[Docket No. 99-SW-80-AD]

#### **Airworthiness Directives; Bell Helicopter Textron Canada Model 206L, L-1, L-3 and L-4 Helicopters**

**ACTION:** Supplemental notice of proposed rulemaking; reopening of comment period.

**Figure 1**

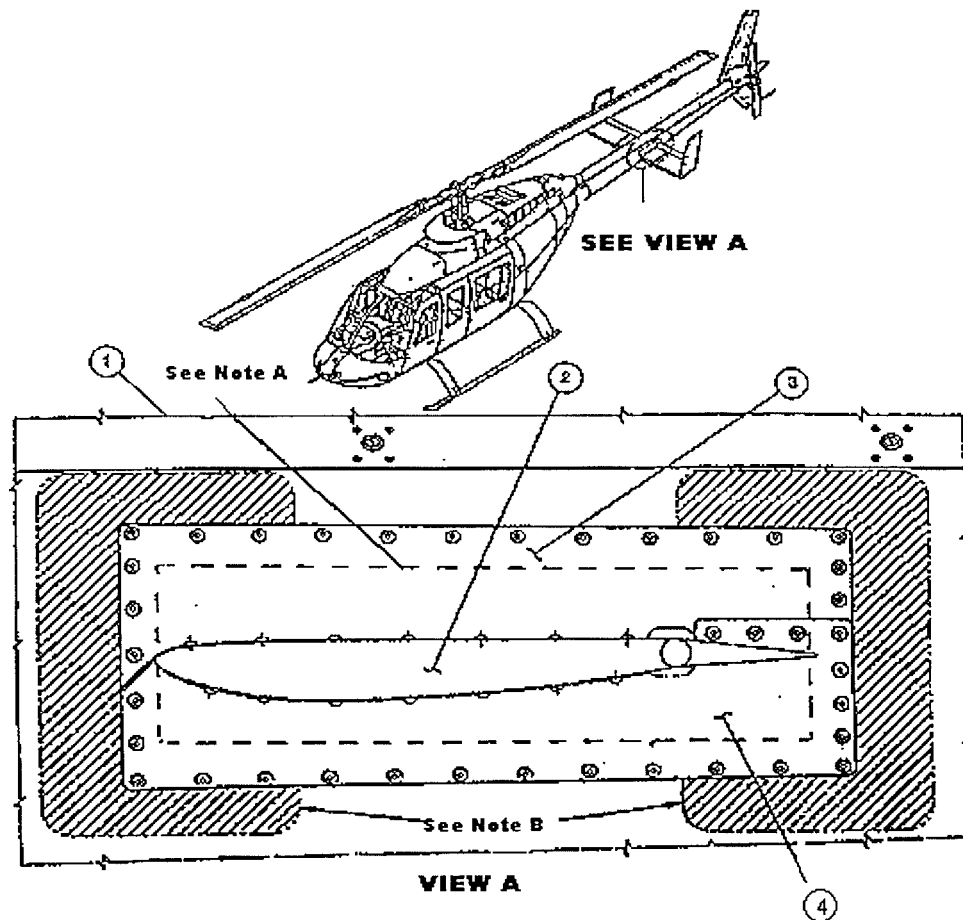
(a) Before further flight and thereafter at intervals not to exceed 10 hours time-in-service (TIS) until accomplishing a one-time fluorescent-penetrant inspection (FPI) required by paragraph (c)(2) of this AD, visually inspect for a crack in the tailboom using a 10-power or higher magnifying glass in the shaded areas as depicted in Figure 1 of this AD:

- A. Inspect entire edge of stabilizer opening on both sides of the tailboom.
- B. Inspect for a crack in these two areas on both sides of the tailboom

(b) At intervals not to exceed 5 hours TIS, visually check for a crack in the tailboom in the shaded areas as depicted in Figure 1 of this AD. The visual check may be performed by an owner/operator (pilot) holding at least a private pilot certificate and must be entered into the helicopter records showing compliance with this paragraph in accordance with 14 CFR 43.11 and 91.417(a)(2)(v).

(2) Perform a one-time FPI of the edges of the tailboom skins for any crack around the left and right horizontal stabilizer openings as shown in Figure 1 of this AD. Remove paint and primer to inspect the edges and exterior skin surface in the skin area at least 3/4 inch around the edges of the horizontal stabilizer openings as shown in Figure 1 of this AD.
